CHANGE ORDER

Contract Number bcjv0119_03
Change Order Number 01
Date 02/07/2023
Project Garage Membrane
Address 2244 W 6th Ave, Vancouver, British Columbia
Owner Vancouver No. 1 Partnership Managed by InterRent Holdings Manager Limited Partnership
Contractor Flagship Construction and Building Envelope Restoration Ltd.

Balconies Curb Wall – as per TCC Report No. 1, dated 2023-01-28

Concrete Wall Remedy & Shoring – Upgrade as per Structural Engineering Review dated 2023-01-26

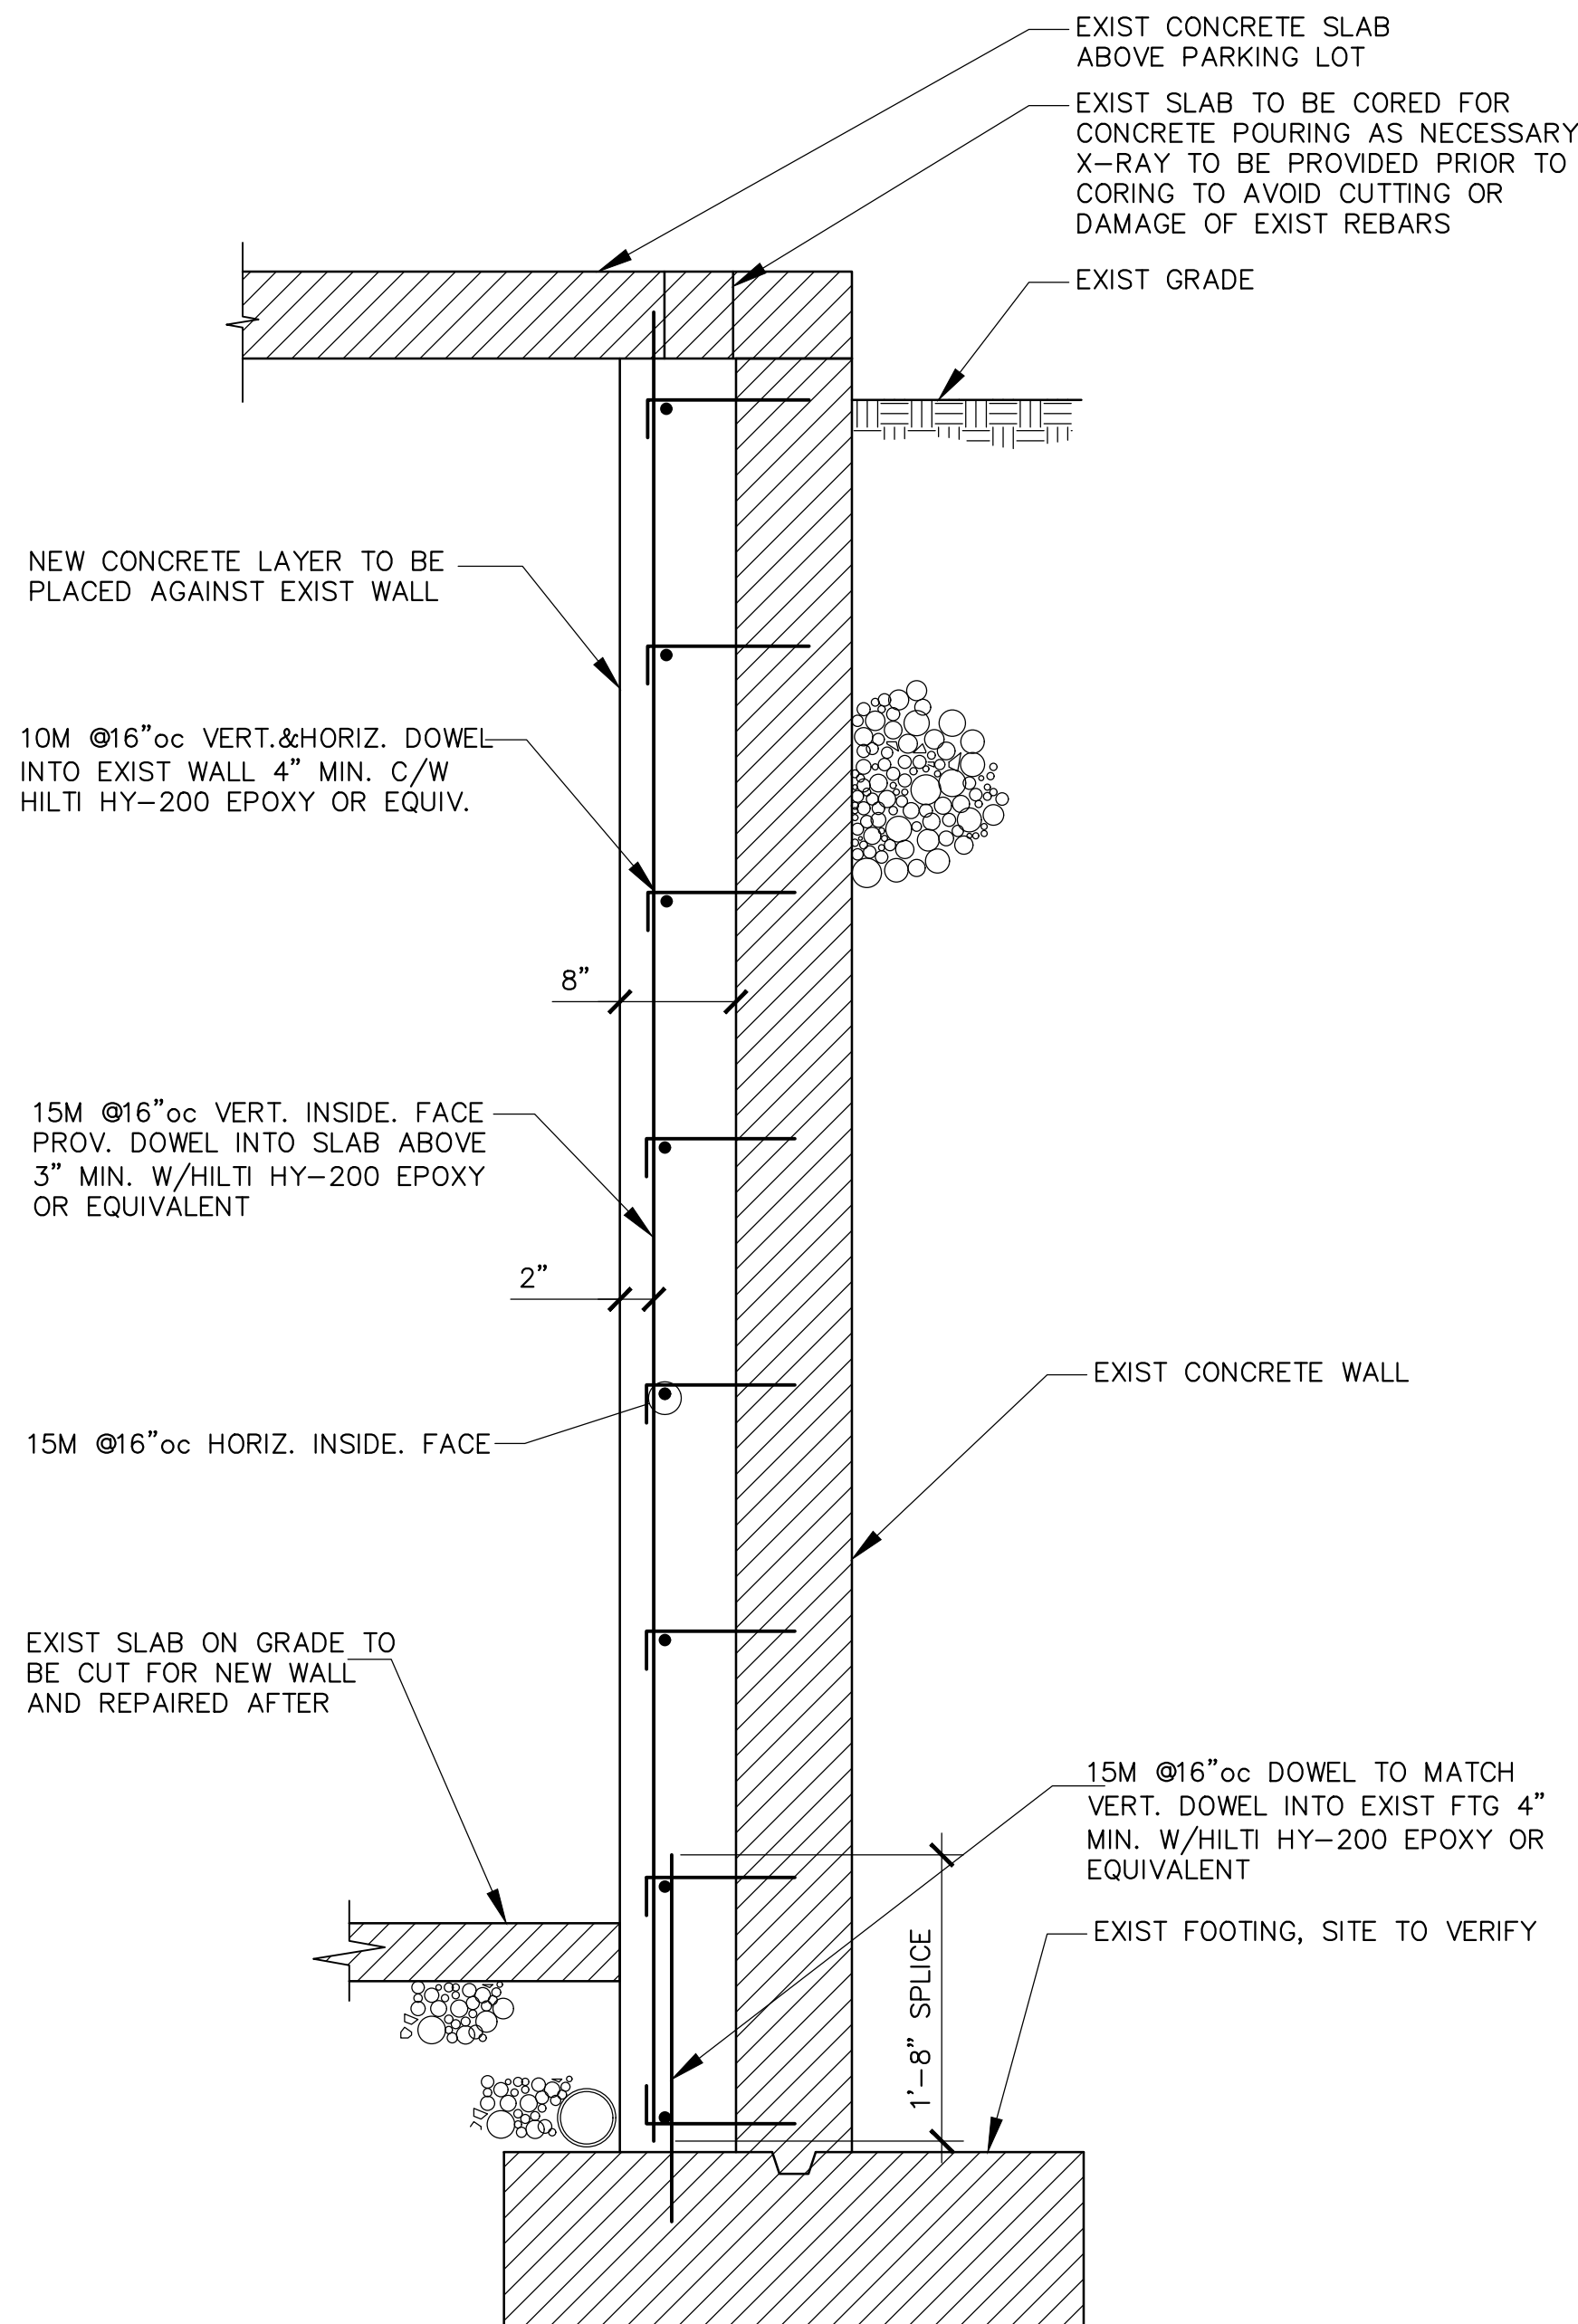
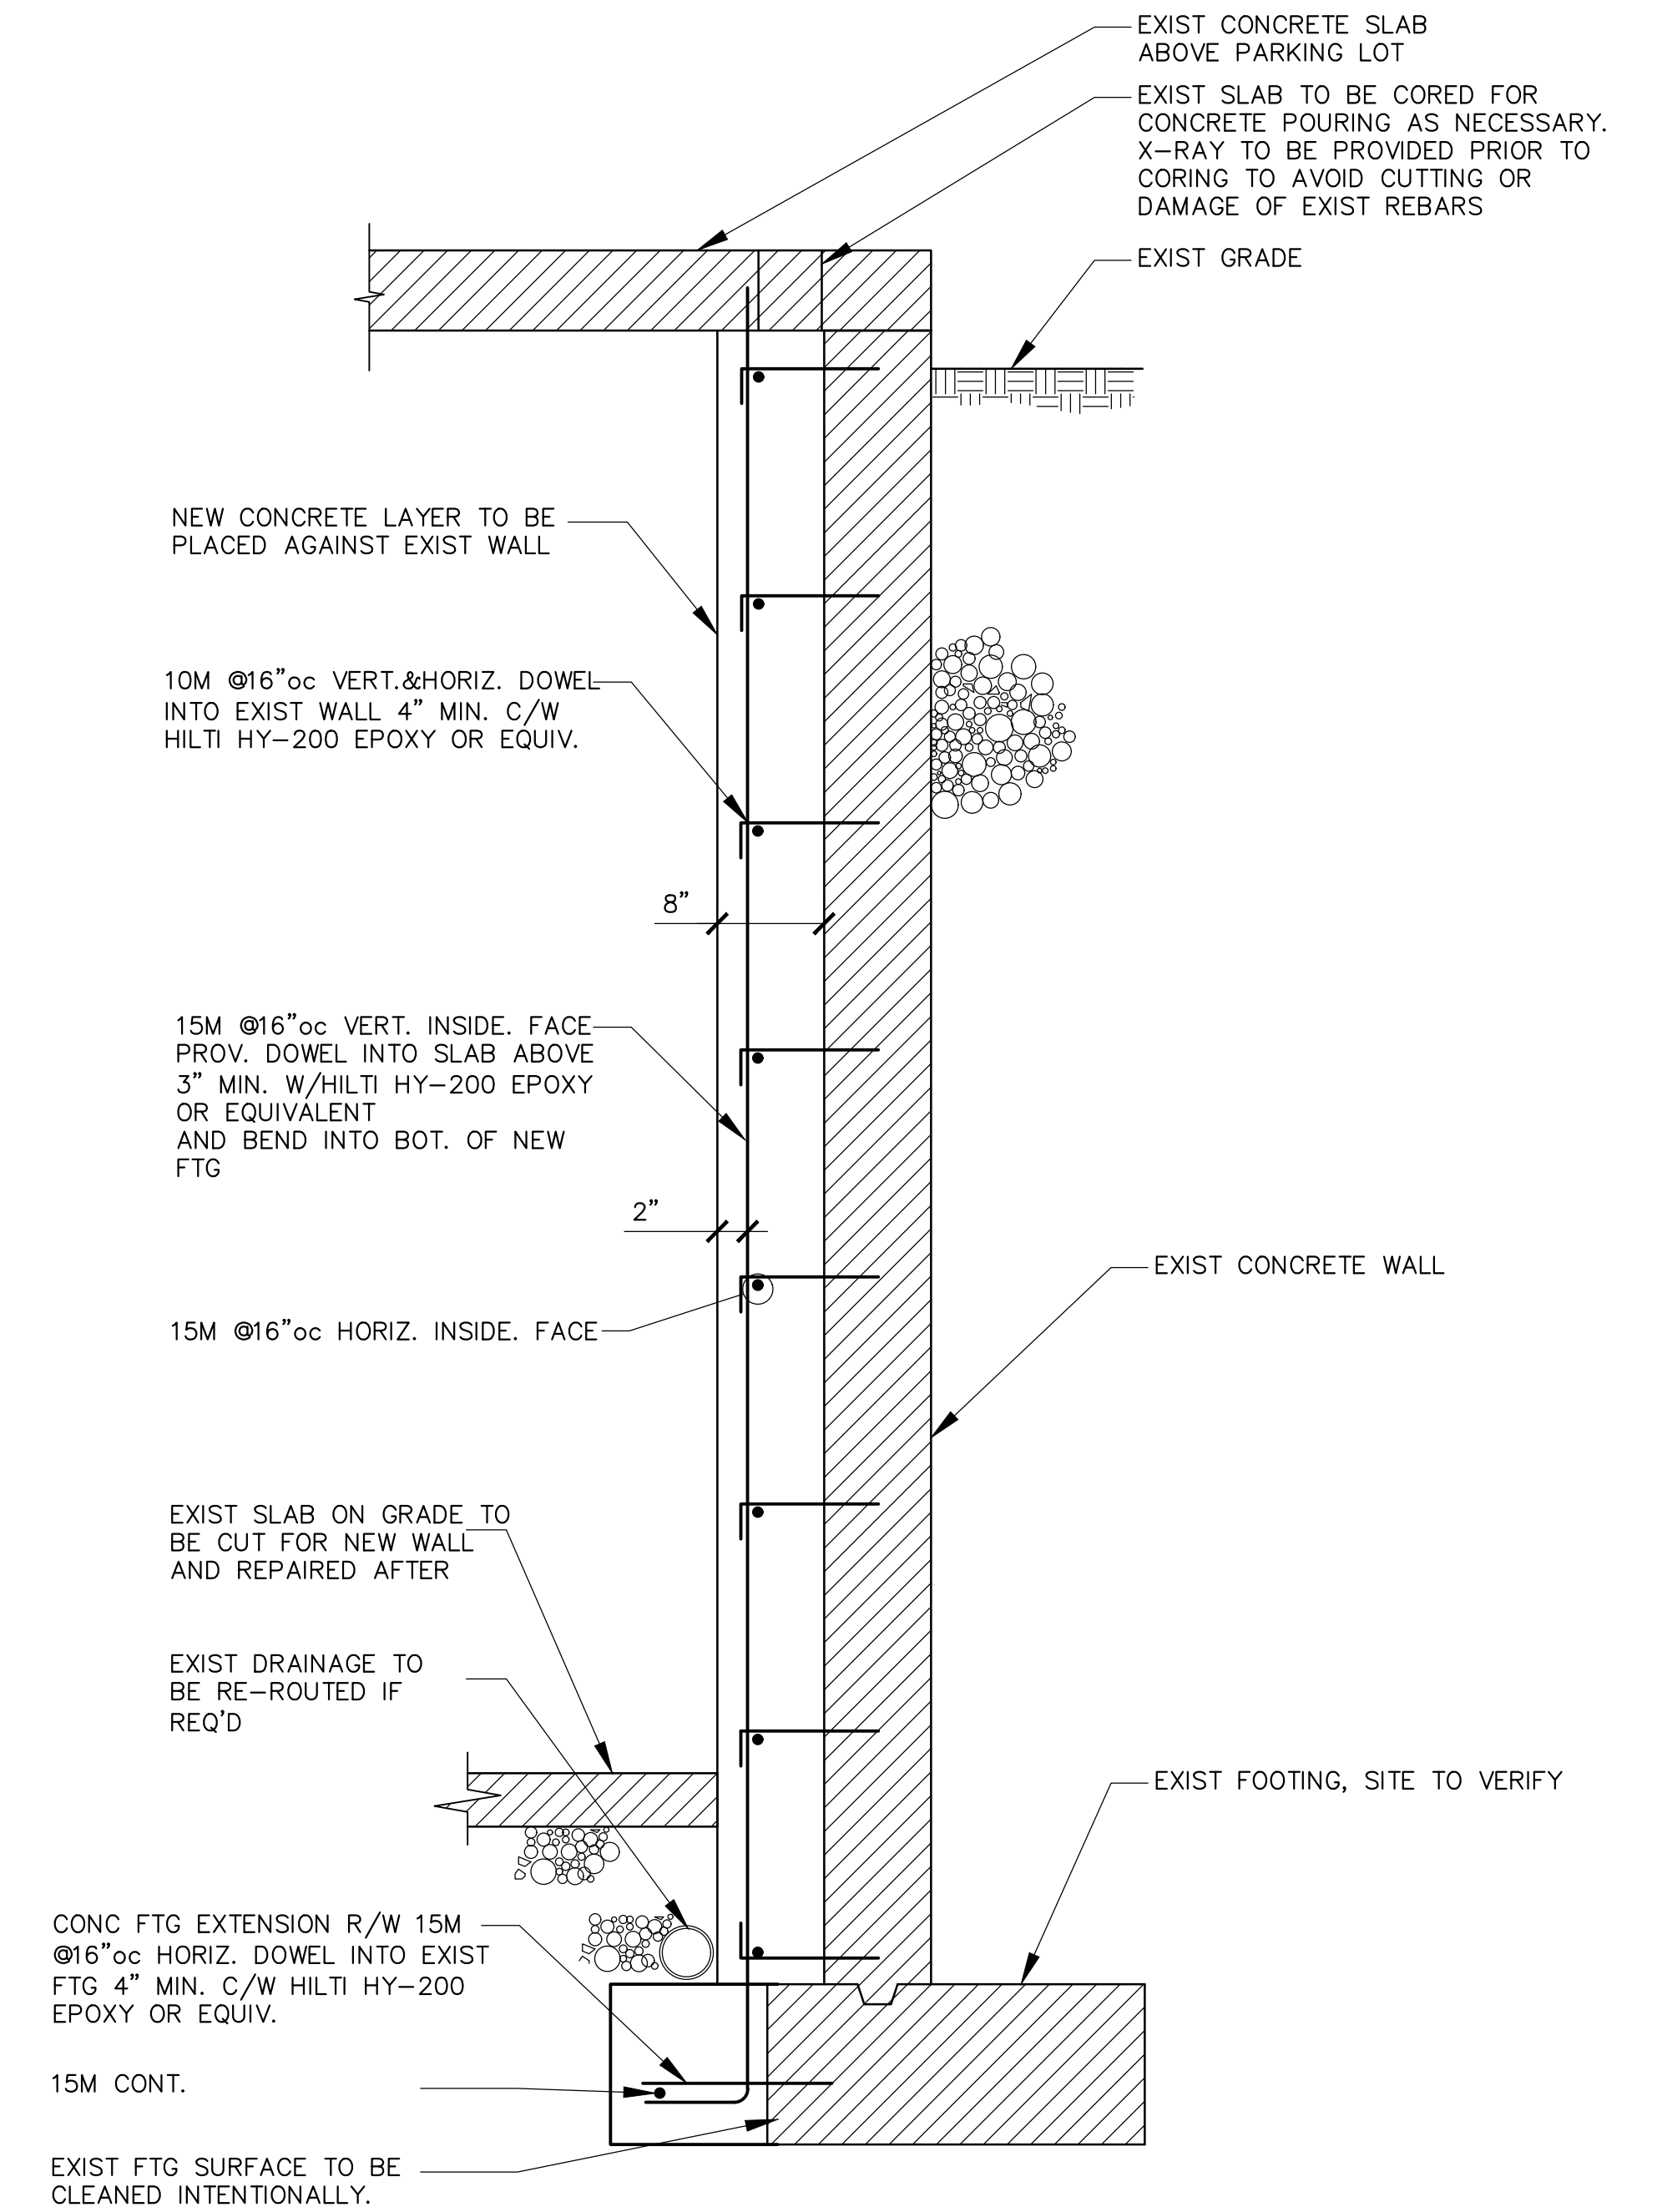
REINFORCING DETAIL OF EXISTING CONCRETE WALL

REINFORCING DETAIL OF EXISTING CONCRETE WALL (CASE 2-IF EXIST. FOOTING EXTENTION REQ'D)

- 1) In addition to the basement wall repair works proposed, the new concrete wall thickening shall be increased to 8" min. to provide adequate bearing support for slab above after its cracking and all the related rebars and dowels shall be increased accordingly. Meanwhile, the new thickening part of wall shall be carried down to foundation as well for the extra gravity load from slab. The existing slab on grade shall be cut to suit this and repaired after. The existing foundation might be expanded and reinforced after excavation, if required.

Picture 2: only bottom reinforcing found from X-Ray

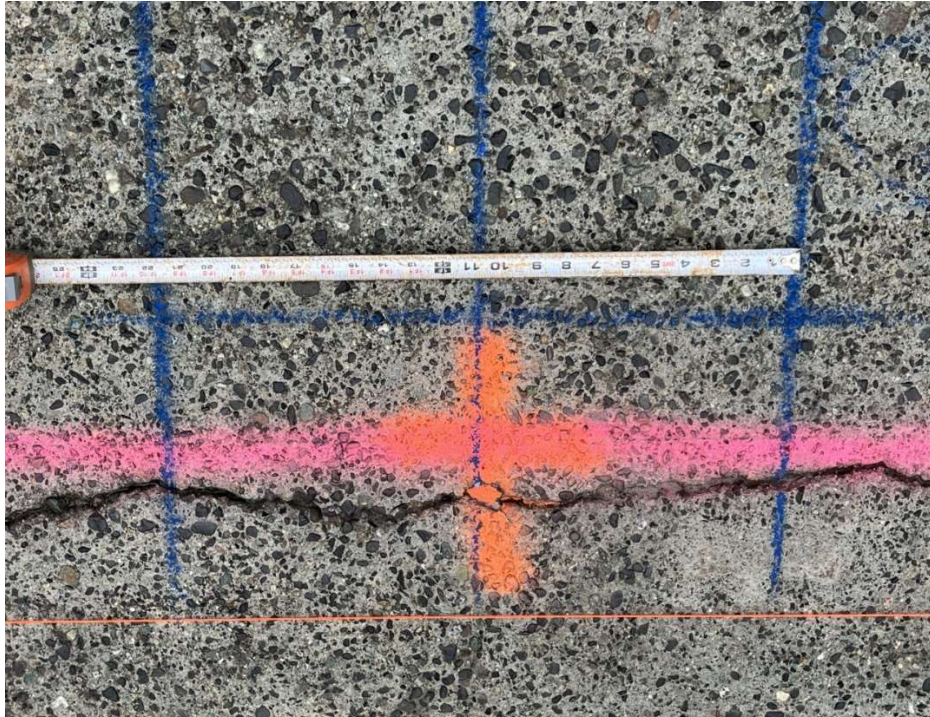
- 2) It was also observed on site that there was no cold joint between the concrete slab and basement. The slab and wall were placed monolithic without providing any top reinforcing at slab edge which doesn't meet the concrete construction standard at all. (See picture 2 for reference) The blue rebars scanned are all bottom ones. Therefore, the negative bending at the edge of slab along the basement wall caused a significant tension at top of slab and directly resulted in the cracking of slab from the top. This cracking has been developed and almost extended to the bottom rebars at some locations as a long-term effect. (See picture 1A). It can also be concluded by observing the cored cylinder from concrete slab on site. (See picture 3 & 4)
